Technical Service Bulletin

No.A206-07
04 April 2005

Subject/Concern:	Creak/Chirp Noise Emanating from the Rear of the Vehicle Over Rough/Uneven Surfaces
-------------------------	---

Models:		
X-TYPE		VIN-range: C00294-E45113

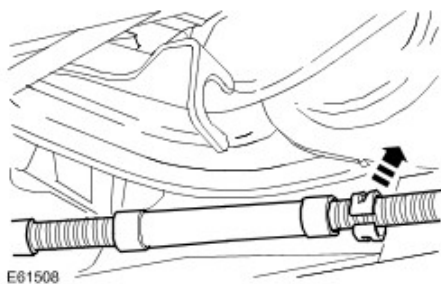
- 1 . Raise vehicle on ramp.
- 2 . Detach the rear parking brake cable from the mounting.

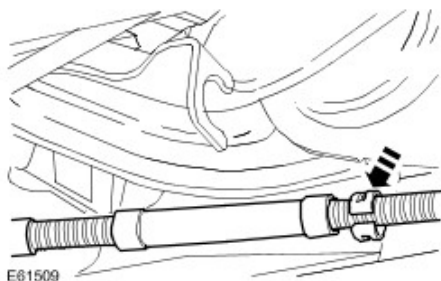
- 3 . Detach the C-clip from the rear parking brake cable.

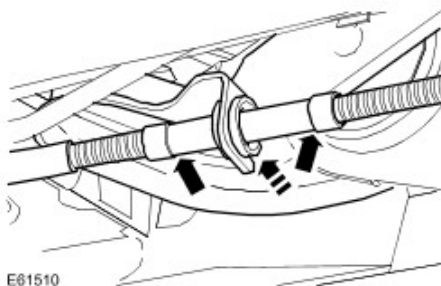
- 4 . Install the new C-clip to the rear parking brake cable.

- 5 . Install the rear parking brake cable to the mounting, ensuring the C-clip is in the centre of the crimps.
